parts bulletin

No. 94-3

WATER TUBE DESIGN CHANGE 6-15 H.P.(Replaces #94-1)

6-15 H.P./XR10/Magnum 10 SeaPro 10/Marathon 10 Serial # All

Design II Water Tube

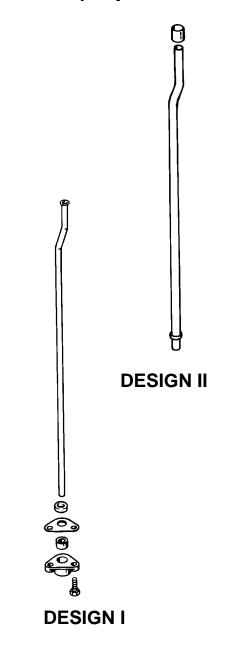
The way in which the upper water tube attaches to the adaptor plate has been improved. These improvements required machining changes to the adaptor plate that do not allow the previous water tube components (Design I) to be compatible.

To replace your adaptor plate, you must order an adaptor plate (listed below) **AND** the appropriate DESIGN II water tube

41344--9 Adaptor Plate (No Exhaust Tube)

41344A6 Adaptor Plate (With Exhaust Tube)

32-826835A1 (Short) 32-826836A1 (Long)

<u>NOTE</u>: Discard the old water tube mounting hardware.
